Architectural Review Board Agenda  
4:00 PM Wednesday, July 27, 2022  
Sussex Civic Center – Village Board Room Second Floor

TO: Architectural Review Board  
FROM: Jeremy Smith, Village Administrator  
RE: ARB meeting for July 27, 2022  
DATE: July 18, 2022

### **III. Consideration and possible action on the site, architecture, lighting, landscape and sign plans for Industrial Controls (N56W24842 North Corporate Circle).**

Sheet No.  
**A2.0**

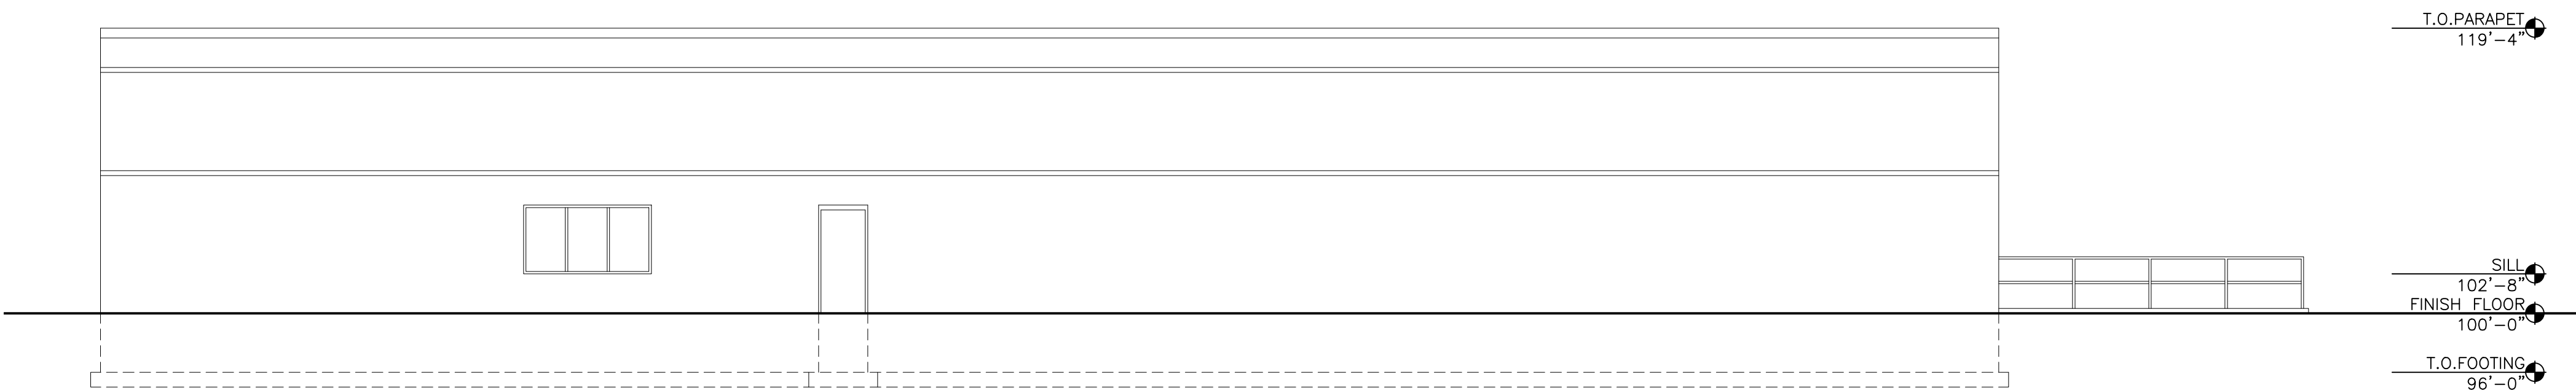
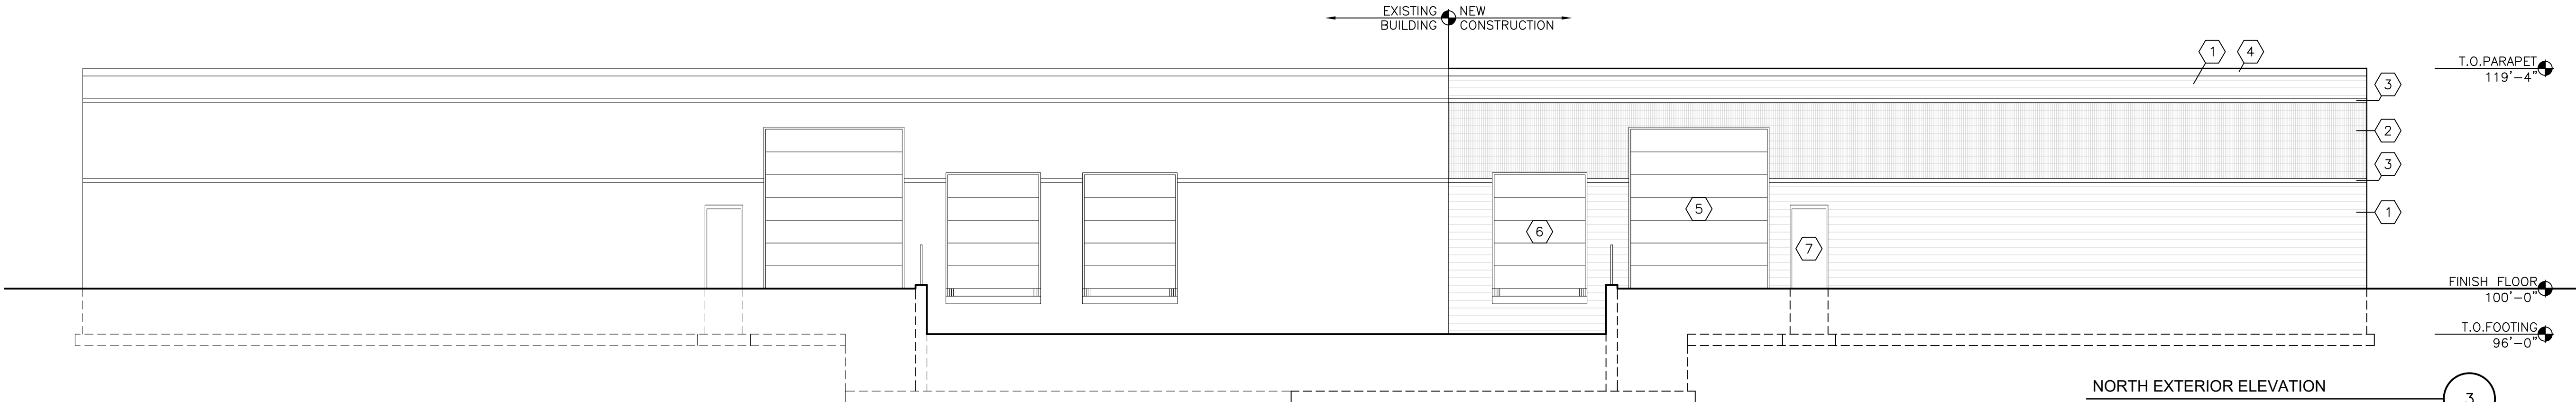
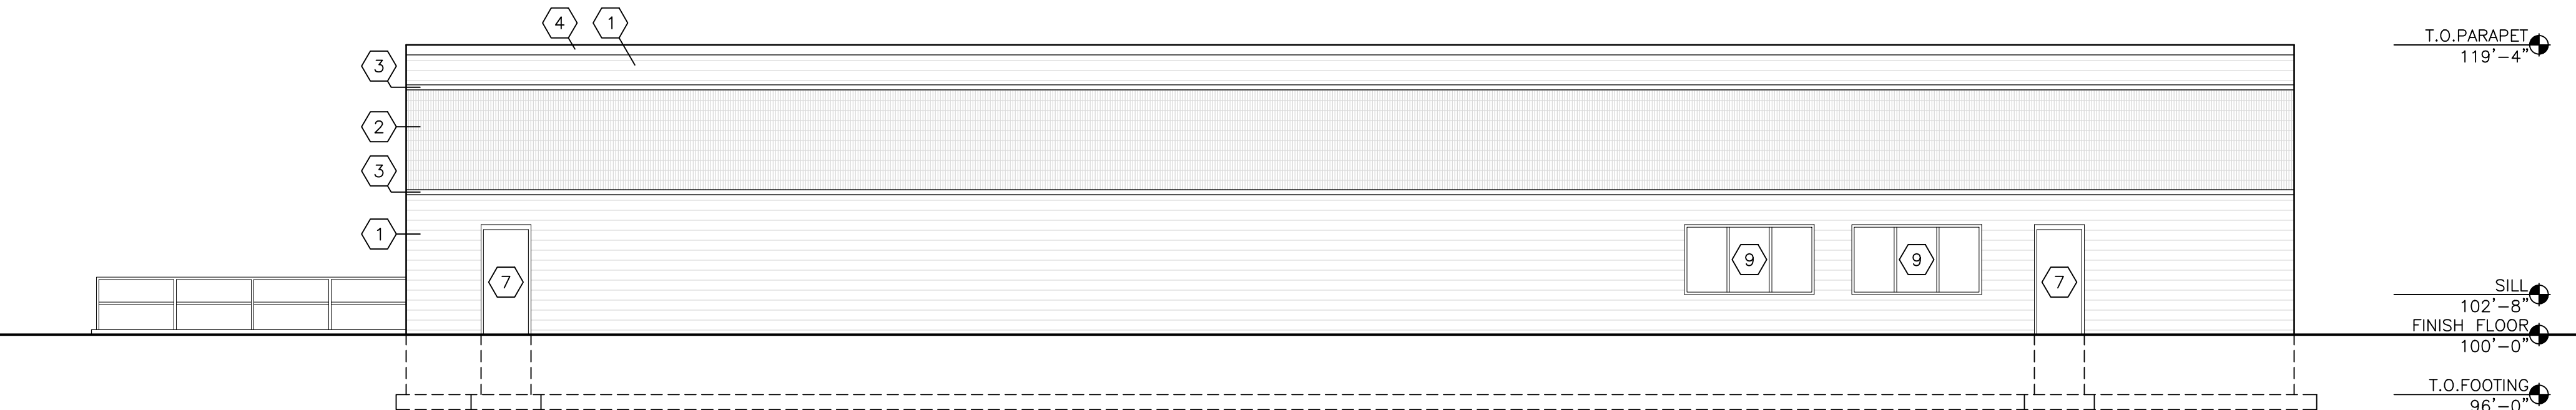
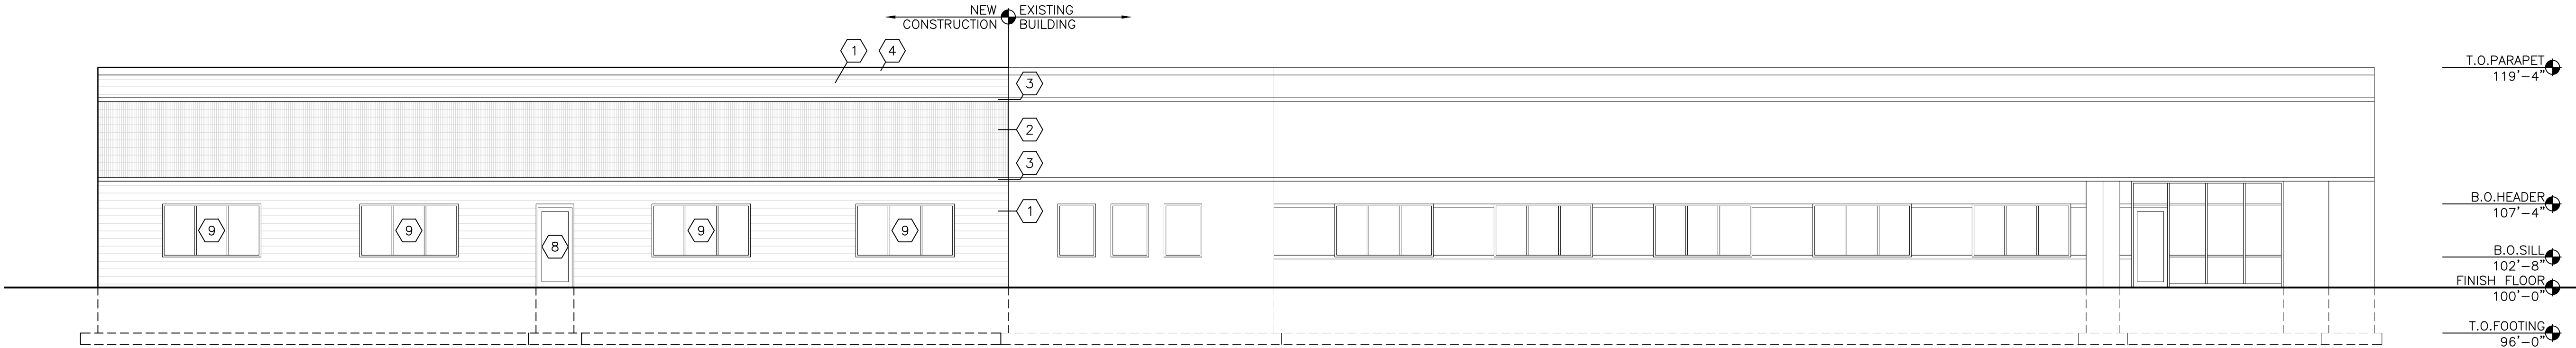
**Staff Recommendation:** Staff recommends the ARB recommend approval of the site plan, architectural plan, lighting plan, landscape plan and sign plan for Industrial Controls subject to revisions to the landscape plan to add 1 tree, screening of rooftop units, and adding of gates to garbage enclosure and any other conditions from the ARB.

# LSP1.1

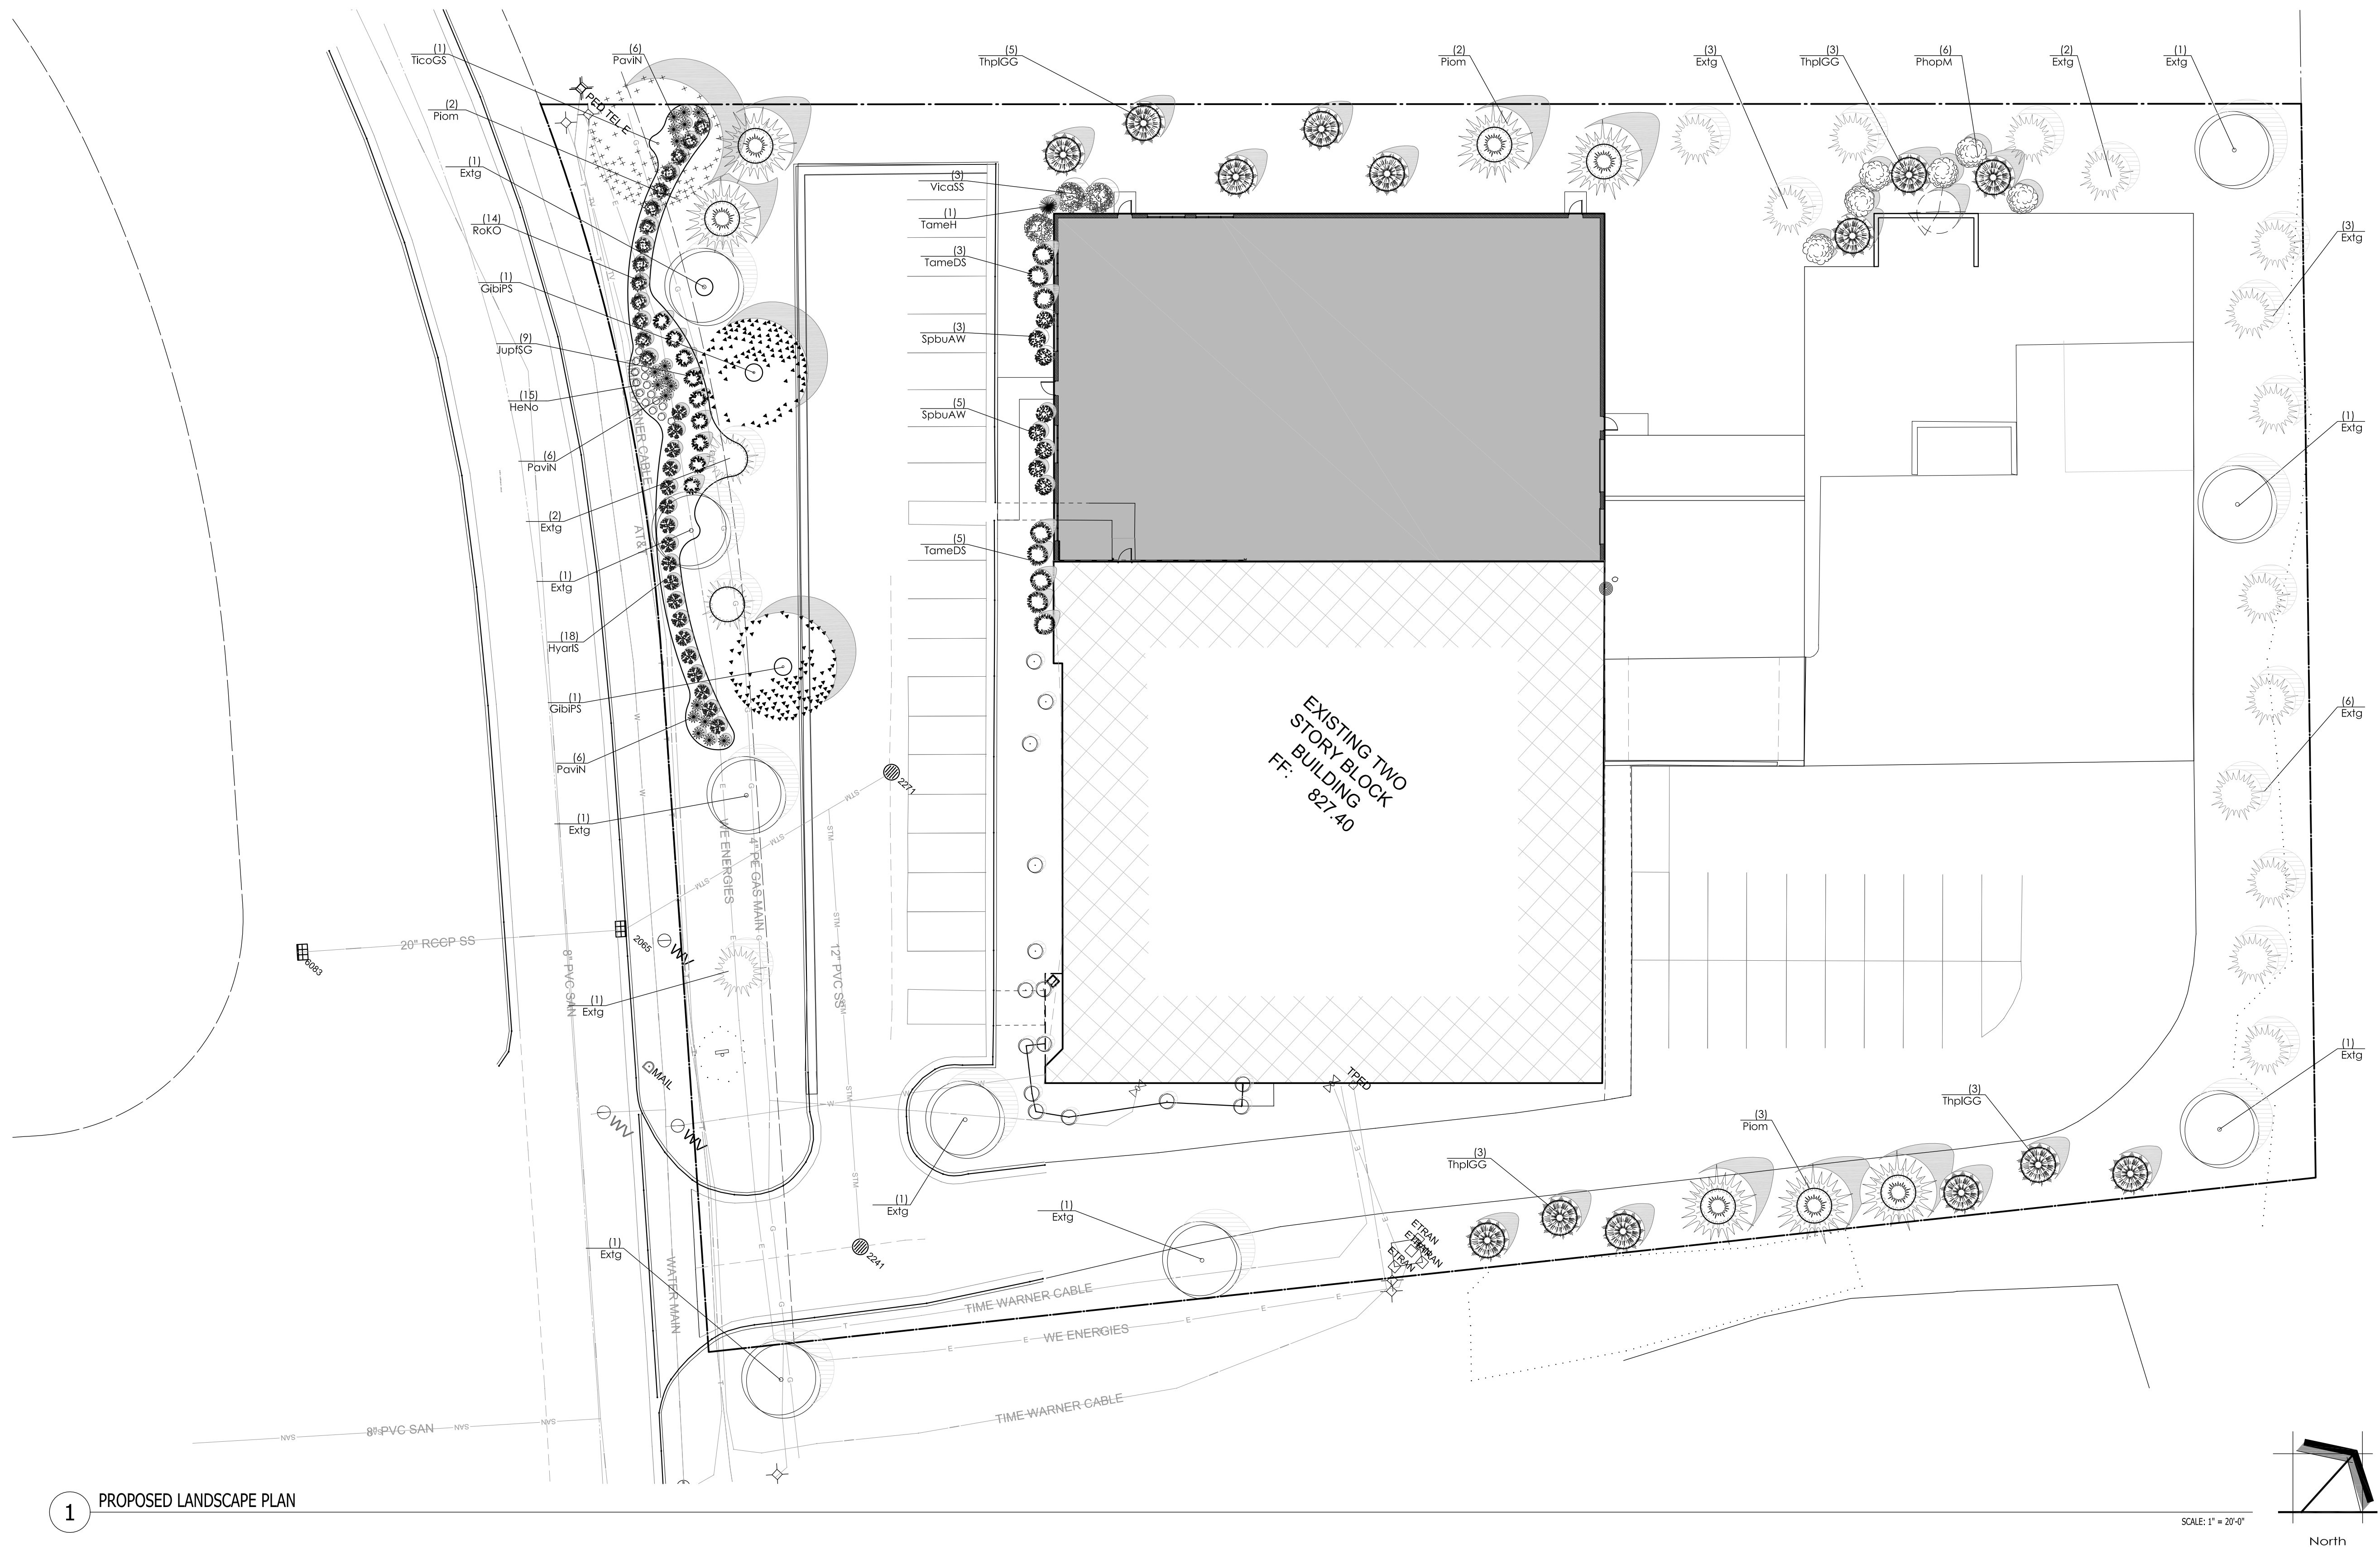
- The site has 51 trees, when 52 are required. Trees are well spaced around the site and 1 should be added in a reasonable location (avoiding underground utilities. The site has 115 shrubs, grasses, perennials when 260 are required. The site is well landscaped given the site parameters from existing conditions and staff recommends no additional shrubs/flowers be required at this time.
